Firmware Release Notes

ControlLogix SynchLink Module

Catalog Number 1756-SYNCH

These release notes describe module and software restrictions and anomalies that exist when using the 1756-SYNCH module, Series A, Firmware Revision 2.18 with RSLogix 5000 version 11 or greater.

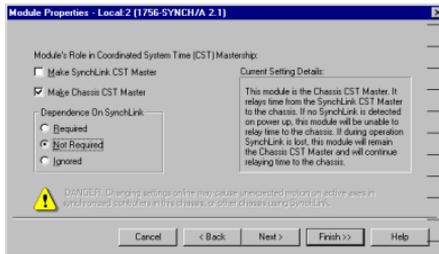
- The module stops relaying time to the chassis. In this case, the chassis is unsynchronized once communications are lost. The software settings for this option are shown below.

The previous module revision (i.e. 1.17) only offered this option when communications with the CST master are lost.

With this setting, there must be a connection with the CST master when the 1756-SYNCH module powers-up. If there is no connection, the module faults and has no CST time until the connection is made the CST master.

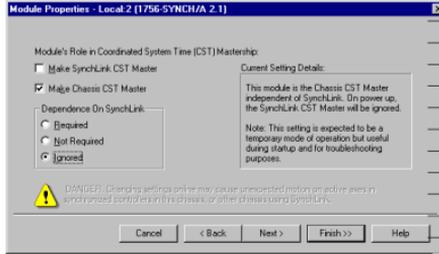
- The module continues to relay time and acts as Chassis CST Master. In this case, you must be aware that this chassis is running unsynchronized motion and you must account for the setting in your application's logic. If communications are resumed over the fiber optic cable, you must do the following to become synchronized with the CST master:
 - Stop all motion connected to this chassis.
 - Reset the 1756-SYNCH module to time relay function

The software settings for this option are shown below.

The CST does not start in this chassis until a connection is made with the CST master, typically at module power-up. If there is no connection to the CST master at power-up, the module faults and has no CST until the connection is made. This is for **firmware revision 2.10 only**. To see how this works with firmware revision 2.18 or greater, see page 4.
